**Attachment 5**  
*Applicant's Design  
Rationale*

## **817 St. Andrews St – PASSIVE HOUSE TRIPLEX**

This summary is both a response to the *Pre-Application Review for 817 St Andrews* letter of September 28 2020, emails of March 2022 from planning and a Design Rationale.

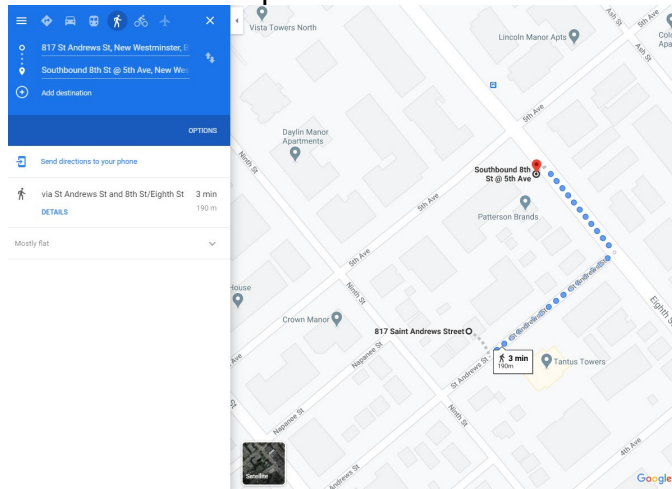
1. HRV exclusion request removed and this area has been added back to the main calculation which brings the project to 0.749 to conform.
2. See associated Arborist report. Only one tree at the rear of the property is proposed to be removed and two new trees added. Adjacent property trees and hedges should not be affected according to the report.
3. Sideyard setbacks have been reduced.
4. A reflected outline of the west facing home has been added to the elevation drawing on sheet A3.1 showing no major privacy issues between new and existing windows. See 2/A3.1.
